## TECHNICAL ATTACHMENTS

**4608-4618 14<sup>th</sup> Street NW**

## District Department of Transportation (DDOT) Comprehensive Transportation Review (CTR) Scoping Form

Scoping Information
<b>Date(s) Scoping Form Submitted to DDOT:</b> 2/19/22
<b>DDOT Case Manager:</b> Emma Blondin
<b>Date(s) Scoping Form Comments Returned to Applicant:</b> 3/10/22, GS responses 3/17/22
<b>Date Scoping Form Finalized:</b>

**Loading and Internal Building Routing**

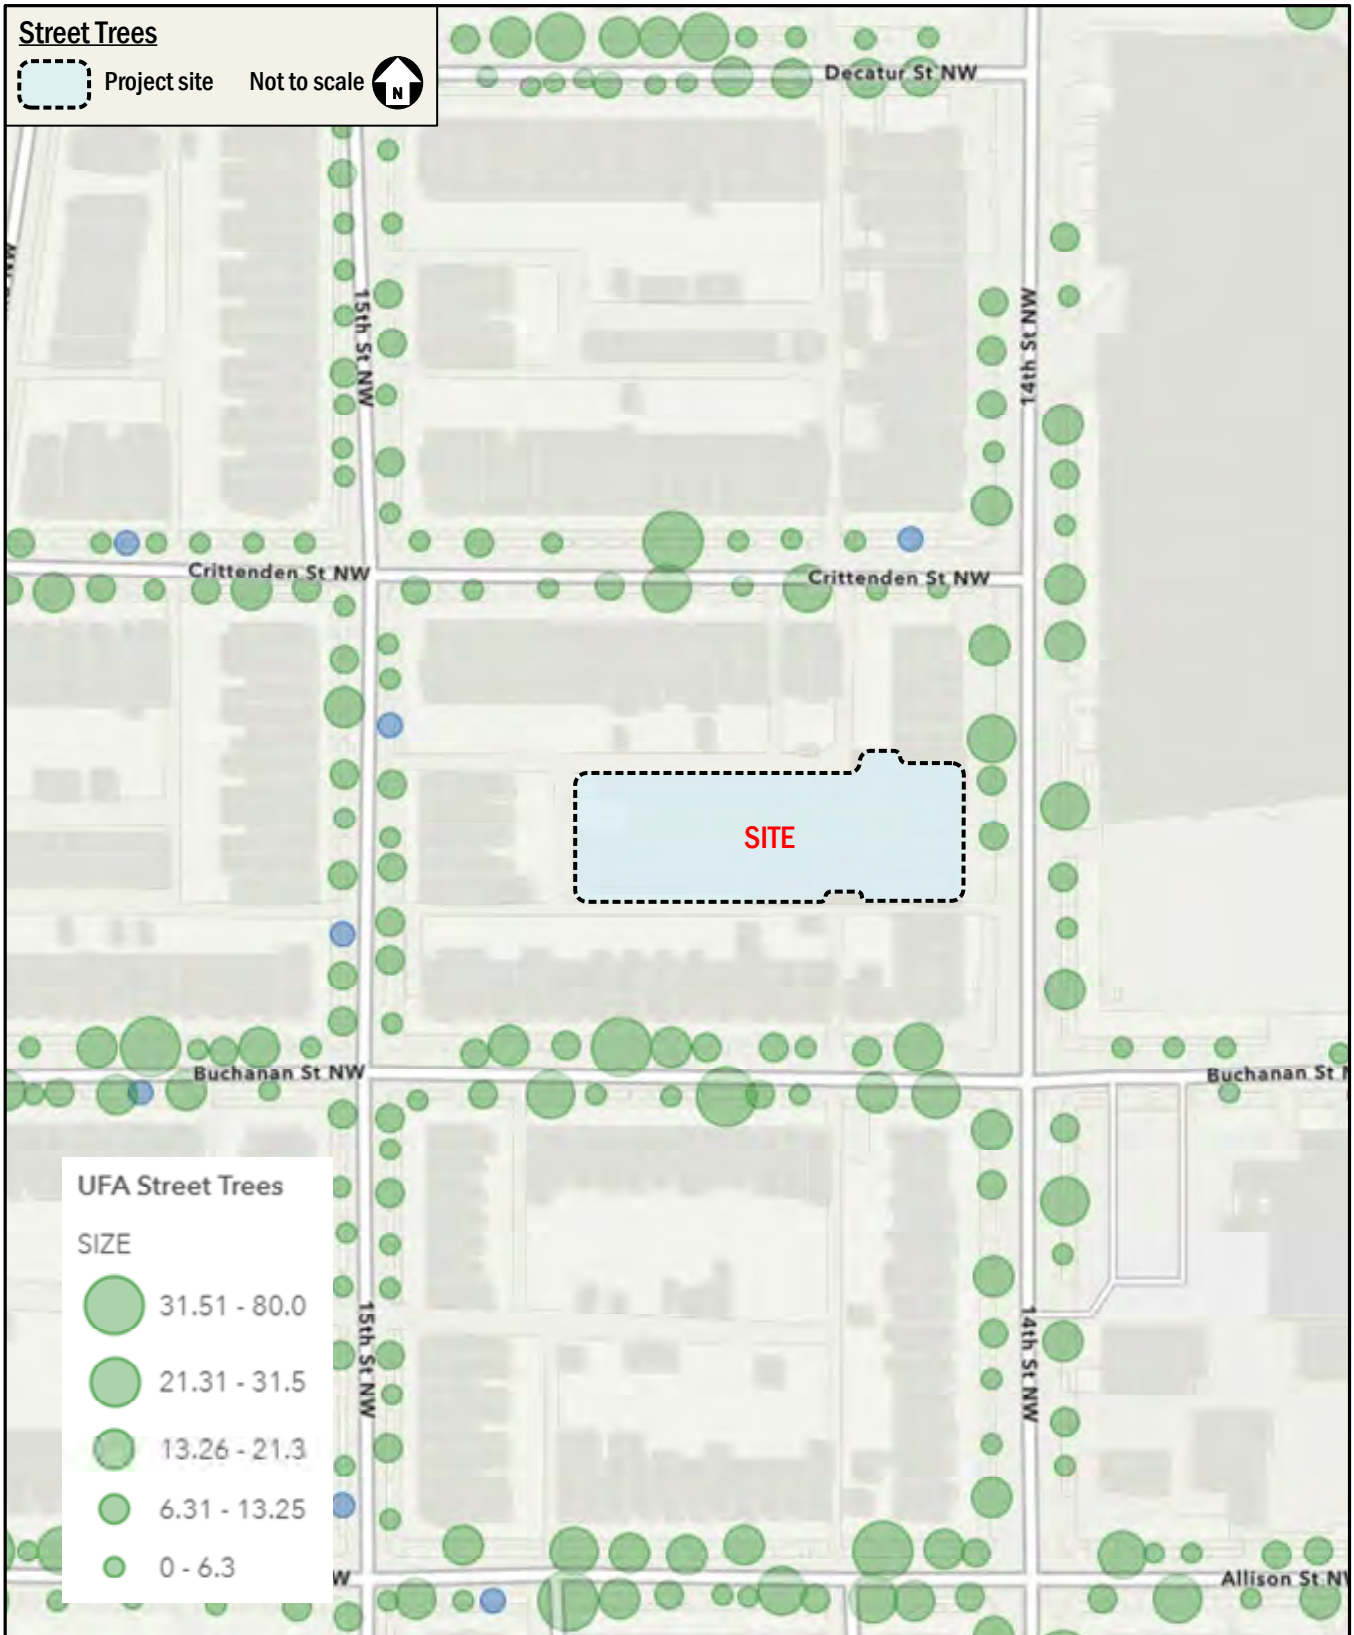
- Include more information about the number and size of delivery vehicles expected
- How or whether they are expected to access the loading area off the alley (Drive in and back into a dock? Park at the curb on 14<sup>th</sup> at wheel goods via dolly into the loading area?)
- How will residential move ins be handled? Is the proposed loading area IFO of the new development intended to be a commercial vehicle loading zone? A parking no entrance zone?

GS response: A LMP will be included in the Statement.

Based on the development size, an average of up to two (2) delivery vehicles per day are expected, including approximately one (1) moving truck for residential move-ins/move-outs and approximately one (1) SU-30 truck for retail, dance studio, and/or theater deliveries.

Delivery vehicles are expected to drive head-in into the alley and the garage, where they will back into a dock. They would then pull head-out out of the garage and head-out to the public street from the alley. The project proposes to widen the alley between the garage entrance and 14<sup>th</sup> Street to increase maneuverability and better accommodate loading vehicles.

Residential move-ins/move-outs are expected to be handled from the 30' x 12' loading berth within the internal loading area.
